# **Description of Amendment/Modification**

Contract GS-11-P-16-YT-C-7173 for the Design Build to Replace Underground Hot Water Loop (NAC) is hereby modified (PS05) to add the following items to the Design-Build Hot Water Loop project at the Nebraska Avenue Complex, 3801 Nebraska Avenue, Washington, DC:

Project: NAC Hot Water Loop Replacement

Mod No: PS05

# NAC Hot Water Loop Replacement PS05

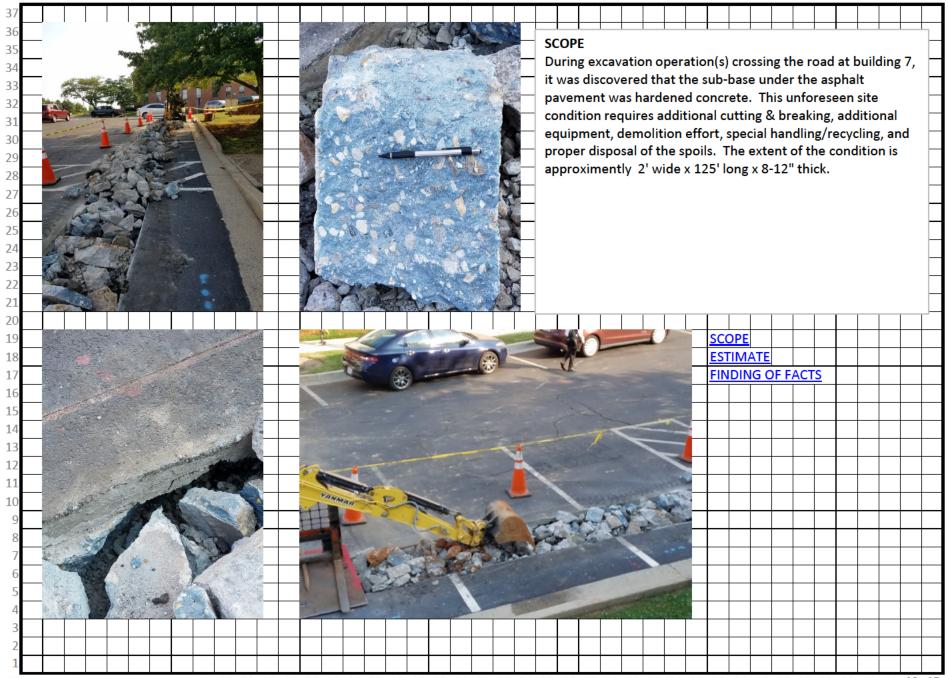
During excavation operation(s) crossing the road at building 7, it was discovered that the subbase under the asphalt pavement was hardened concrete

Furnish all labor, materials, equipment, special handling, supervision, and administrative services to extract, remove from premises, and properly recycle in accordance with contract documents. The extent of the condition is approximately 2' wide x 125' long x 8-12" thick.
